M1-Series Tanks...

OUT WITH THE Old

Dirt and moisture buildup in NBC sponson can lead to NBC filter fire

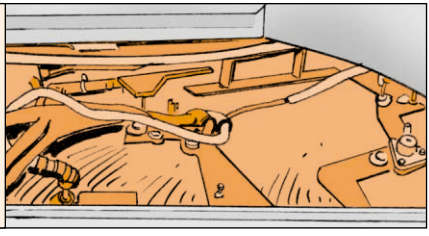
The old annual service wasn't complete enough. Nor was it able to keep up with dirt and moisture buildup problems. That buildup can eventually result in system failure and even an NBC filter fire.

Change 1 (8 Sep 03) to TM 9-2350-264-20-1-5 makes servicing the NBC sponson a semiannual task. The TM change also added some new maintenance procedures, including:

- removing the particle separator and precooler
- inspecting the heat exchanger
- removal of the heat exchanger and condenser for cleaning
- inspecting the fan side of the air cycle machine (ACM) for rust
